HOPE CREEK GENERATING STATION  
DOCKET NO. 50-354  
FSAR COMMITMENT STATUS THROUGH AUGUST 1984

ATTACHMENT I  
HOPE CREEK GENERATING STATION  
FSAR COMMITMENT STATUS THROUGH AUGUST 1984

QUESTION 220.21 (SECTION 3.7.2)

FIGURE 220,21-4  
 RESPONSE SPECTRA COMPARISON,  
 UNIT 1 REACTOR BUILDING AT ELEV. 54' -0"  
 N-S, OBE, 2% DAMPING.

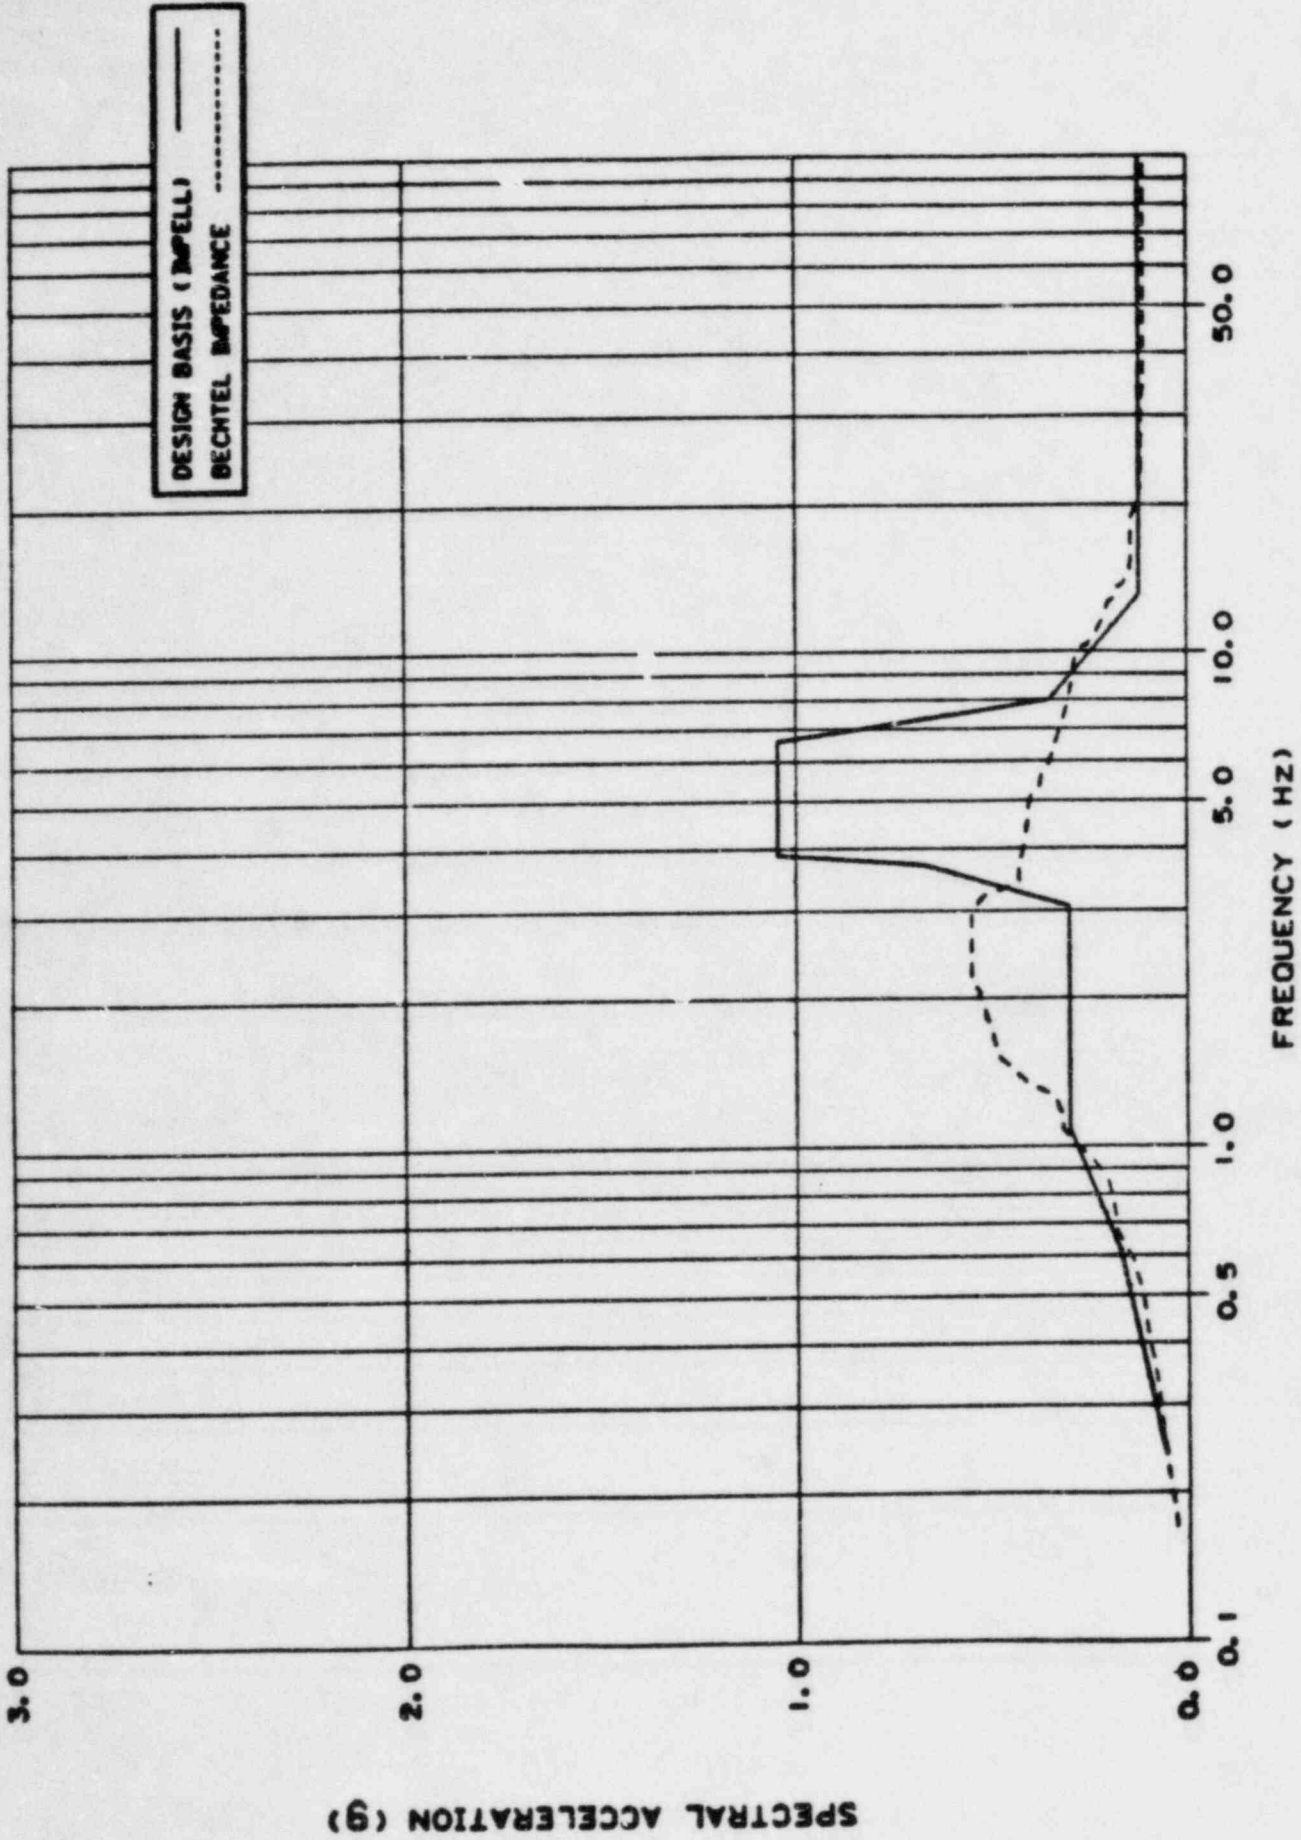
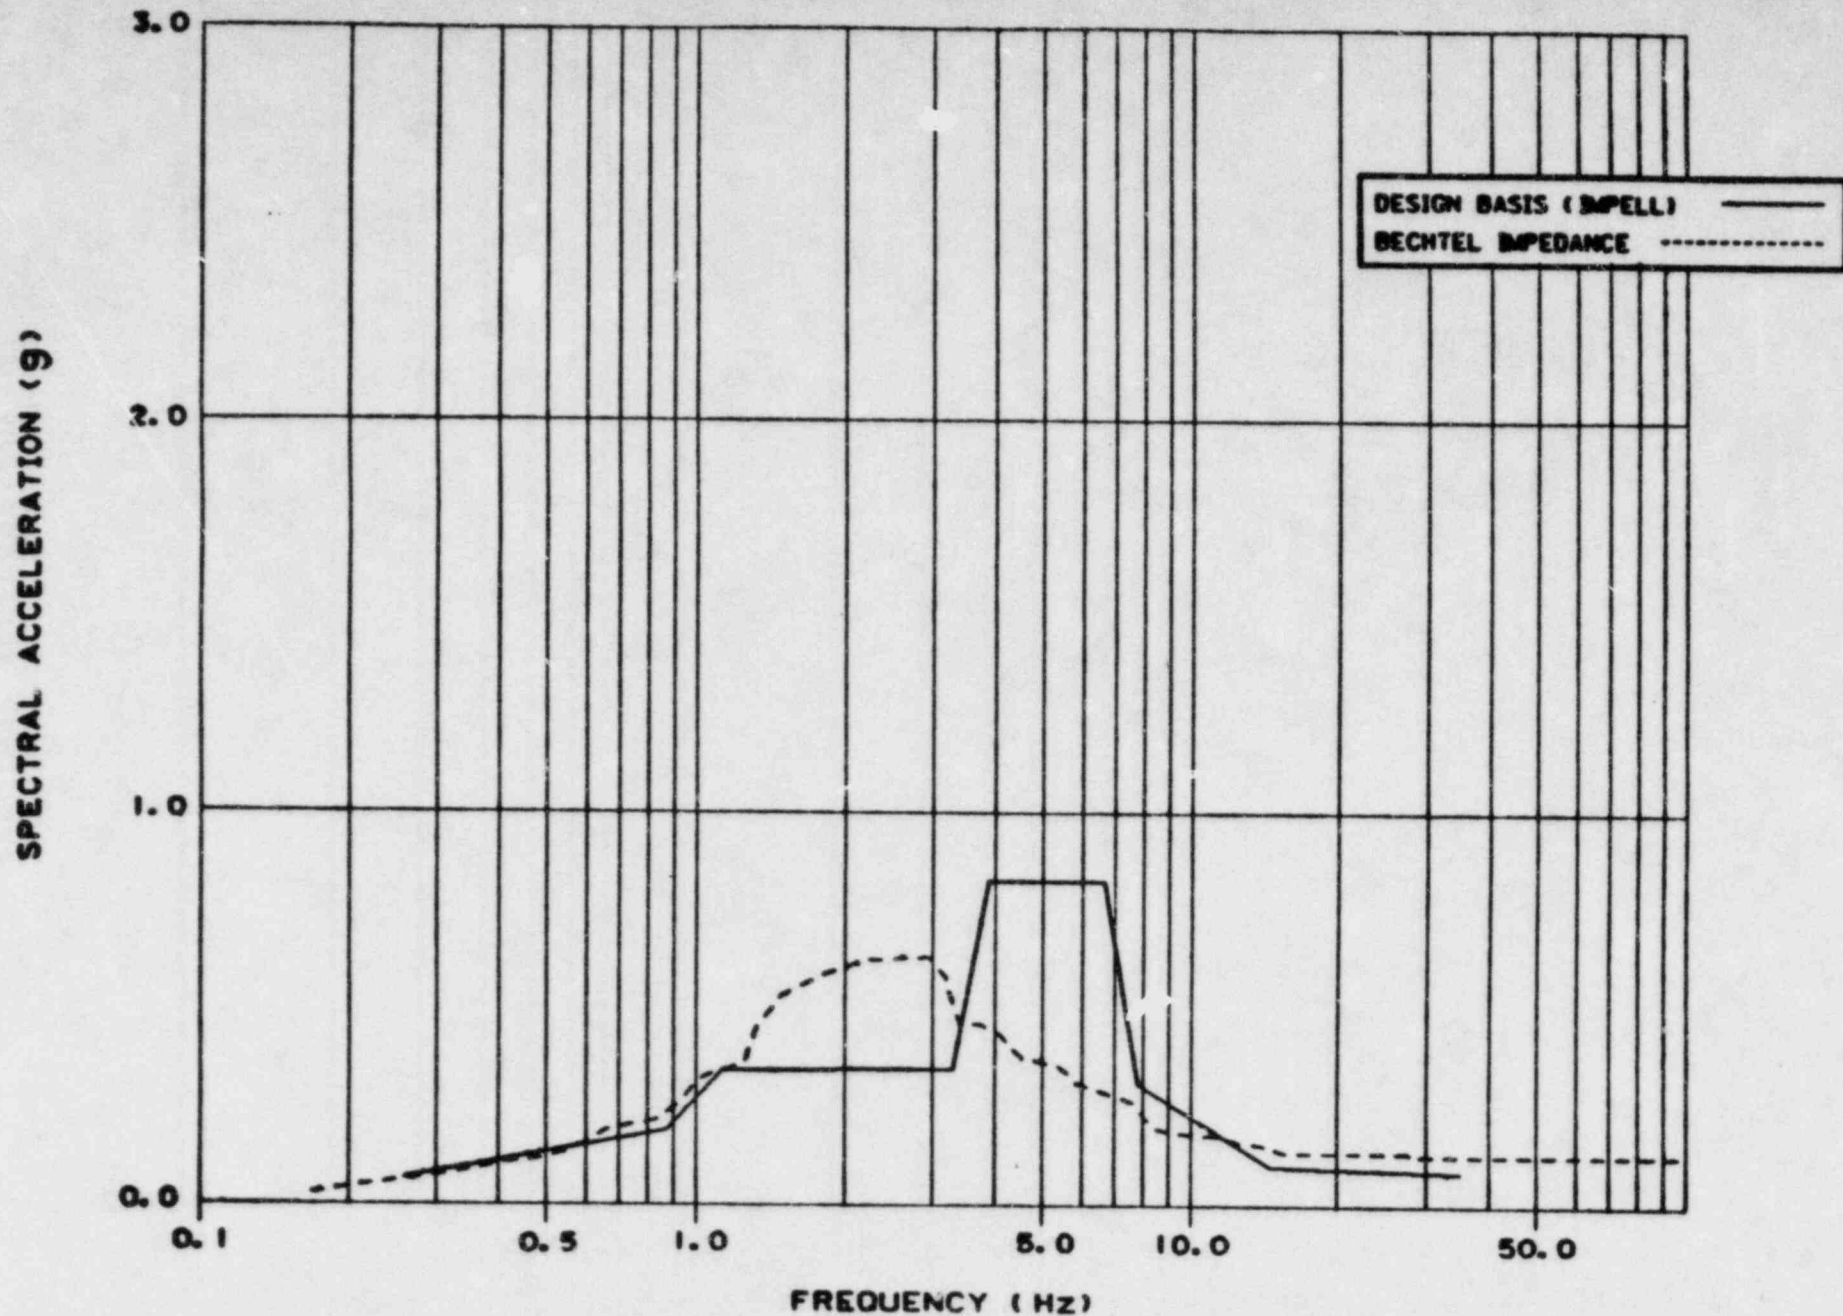
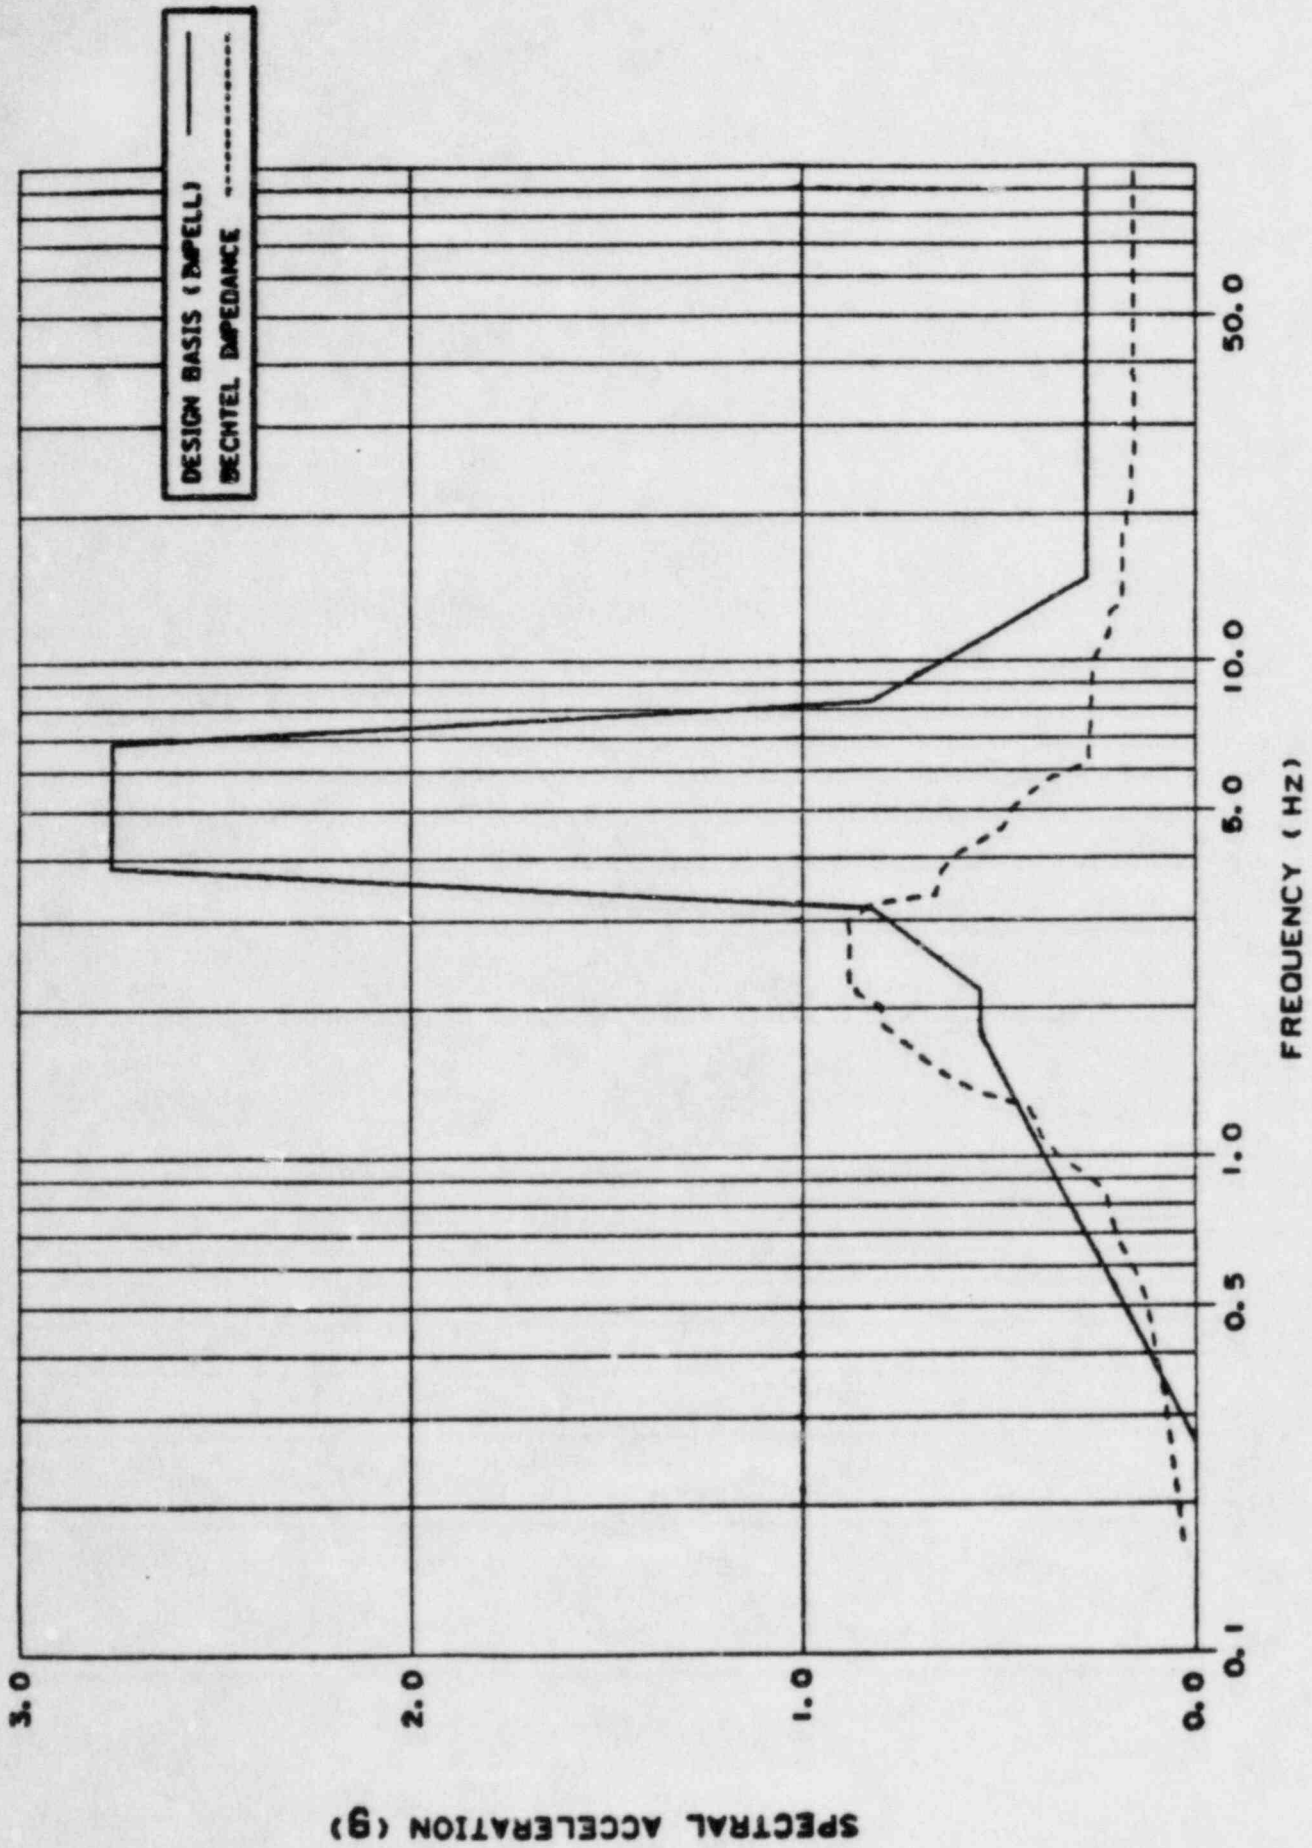
The Hope Creek soil-structure interaction analysis is performed by applying a specified earthquake input motion at the base of the finite-element model. The base level input motion is generated through a deconvolution analysis. The applicable SRP criteria for soil-structure interaction analysis require that both the half-space and finite-element approaches should be considered. (For details refer to SRP 3.7.2-11.4). Public Service should perform necessary analyses to demonstrate conformance to the criteria.

Figures 220.21-1 through 220.21-54 show a comparison of the 2 percent damping response spectra obtained from the design basis finite element and the impedance analyses for the reactor building, auxiliary building and the service water intake structure (SWIS).

¶ For the reactor and auxiliary buildings, the peak spectral accelerations obtained from the impedance analysis are generally lower than those obtained from the design basis analysis. However, the impedance analysis response spectra are not completely enveloped by those obtained from the design basis analysis, especially in the frequency range from 1.0 to 3.5 Hz. Also, there are some local exceedances in the higher frequency range, as shown in Figures 220.21-1 through 220.21-36. ¶ For the SWIS (Figures 220.21-37 through 220.21-54), the impedance analysis response spectra are generally enveloped by those obtained from the design basis analysis at elevation 114.0 feet. For other elevations, the impedance analysis spectral accelerations exceed the design basis spectral accelerations in some frequency ranges. These ranges vary approximately between 1.5 and 10.0 Hz.

forces and moments obtained from the impedance analysis exceeded the design basis values at various locations within these buildings. The auxiliary building seismic shear forces and moments obtained from the impedance analysis are less than the design basis shears and moments.

Since the impedance analysis results are not completely enveloped by the design basis finite element analysis results, sampling studies are conducted to confirm the adequacy of the plant design. These sampling studies include an evaluation of the following items:

In all cases, the items reviewed during these sampling studies can accommodate the loads resulting from the impedance analysis. Therefore, the impedance analysis results have no impact on the plant design.
